SUBJECT: ISSUANCE OF AMENDMENT FOR CALVERT CLIFFS NUCLEAR POWER PLANT
UNIT 1 (TAC NO. 76130)

AMENDMENT TO FACILITY OPERATING LICENSE

Amendment No. 145
License No. DPR-53

ATTACHMENT TO LICENSE AMENDMENTS

FIGURE 3.4-2a
CALVERT CLIFFS UNIT 1 HEATUP CURVE, 12 EFP
REACTOR COOLANT SYSTEM PRESSURE TEMPERATURE LIMITS

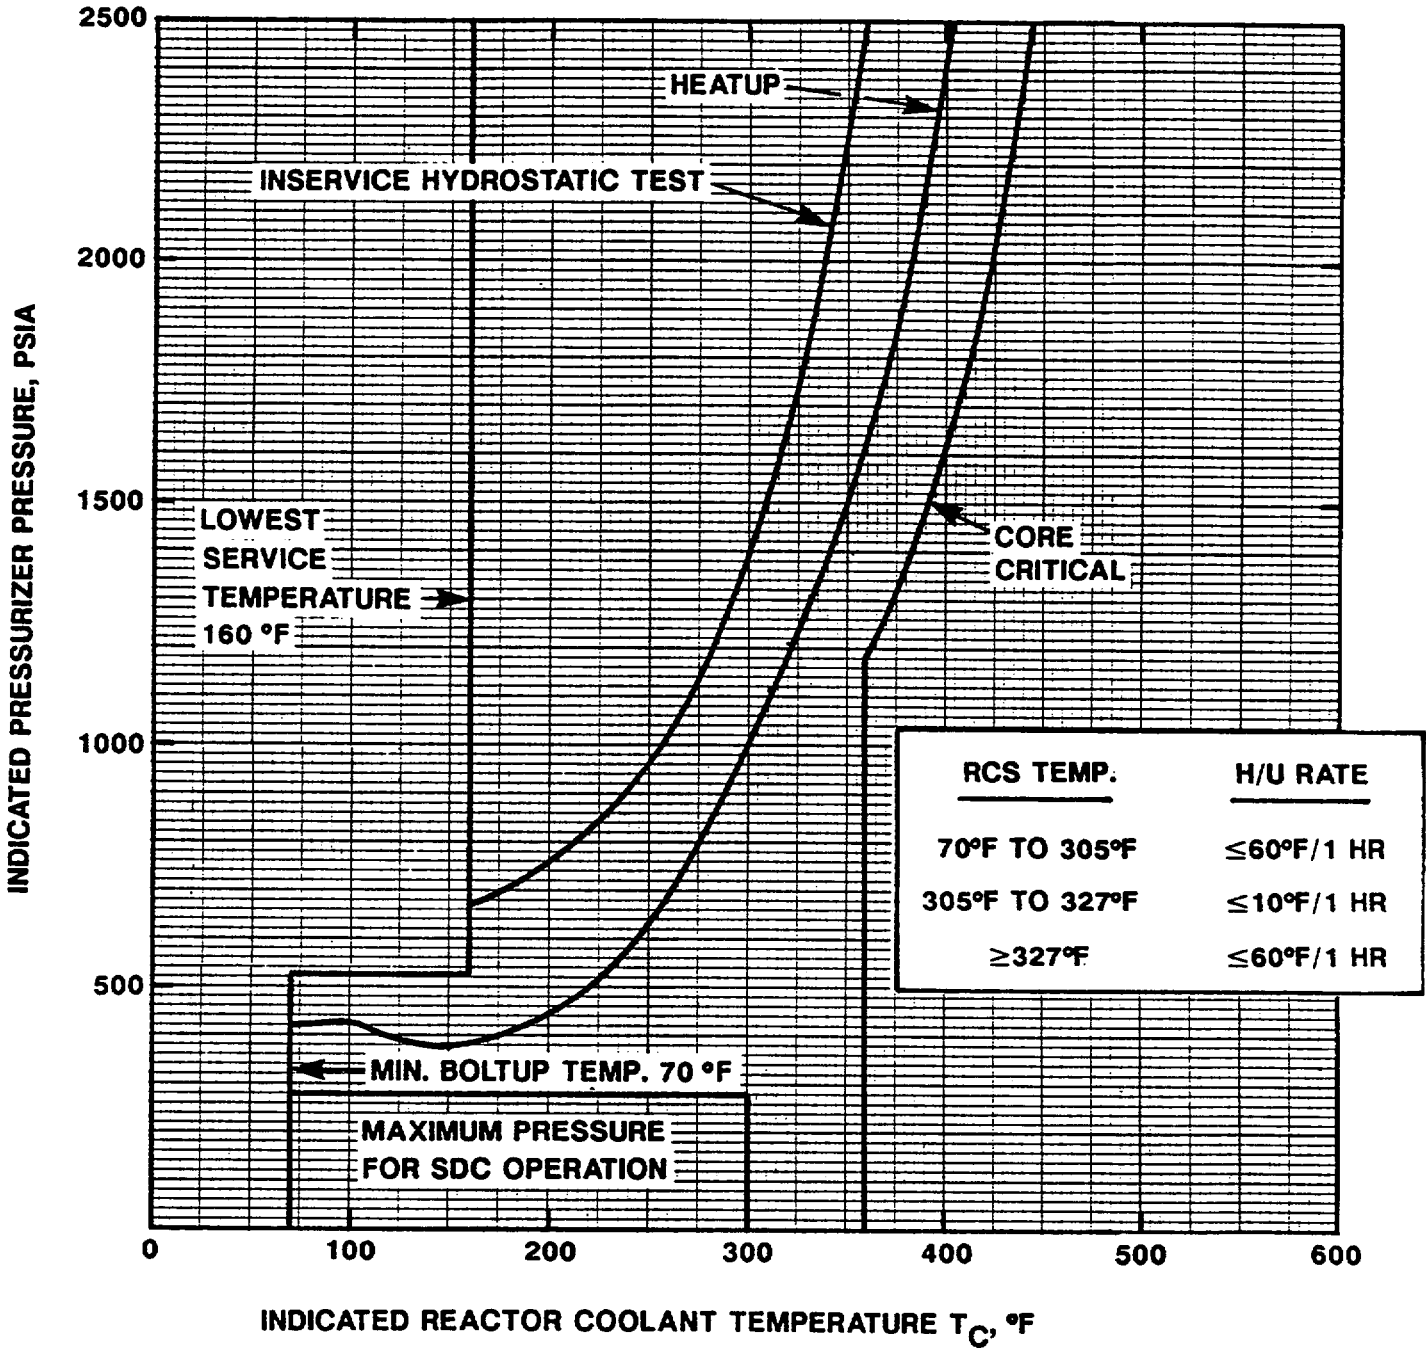
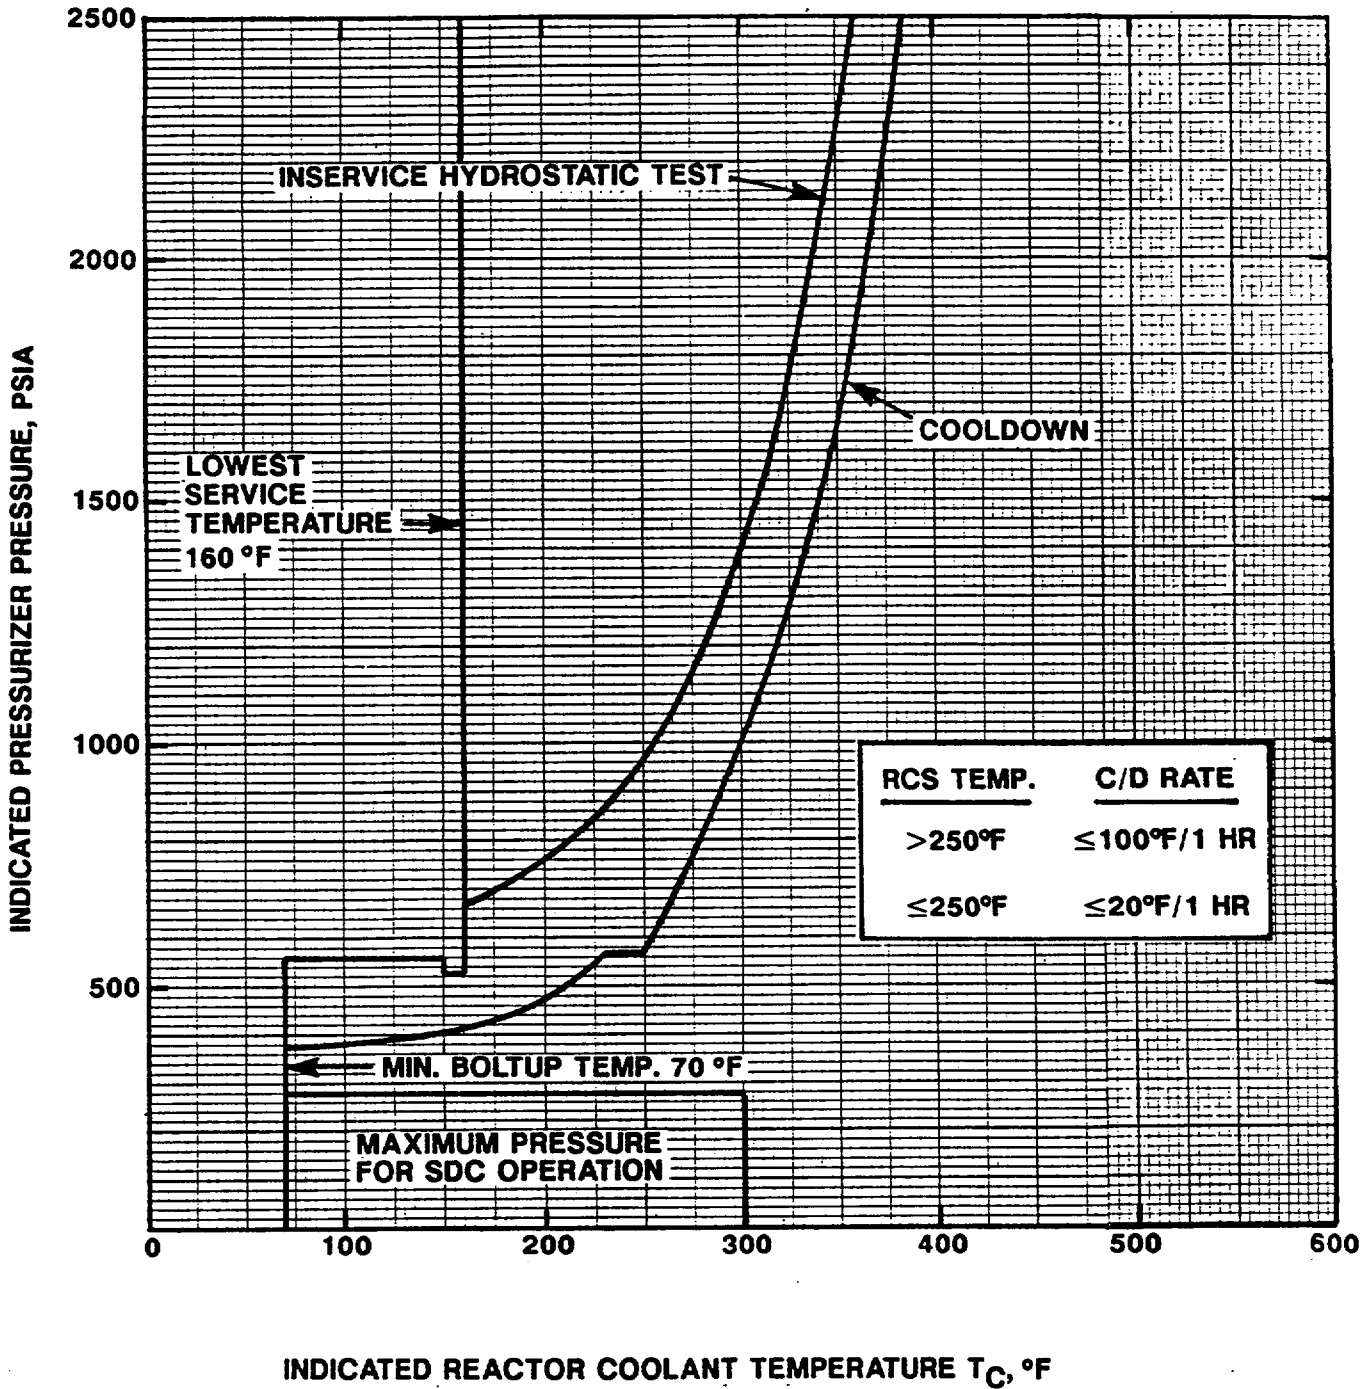
This amendment replaces the existing 0-10 effective full power years (EFPY) and 10-40 EFPY heatup and cooldown curves with 0-12 EFPY heatup and cooldown curves. These curves are based on the final version of Regulatory Guide 1.99, Revision 2, and use Combustion Engineering methodology, which has been previously reviewed and approved. These new calculations resulted in Technical Specification changes to the low temperature overpressure protection (LTOP) controls, the reactor coolant pump (RCP) controls, the high pressure safety injection (HPSI) operability and the HPSI controls which are also reflected in this amendment. Your letter dated July 18, 1990, modified the initial submittal and requested that the Commission handle the proposed amendment, as modified, on an emergency basis. The details relating to the requested changes, the emergency circumstances and a Final Determination of No Significant Hazards Consideration are included in the enclosed Safety Evaluation.

3.4.9.1 The Reactor Coolant System (except the pressurizer) temperature and pressure shall be limited in accordance with the limit lines shown on Figure 3.4-2 during heatup, cooldown, criticality, and inservice leak and hydrostatic testing with:
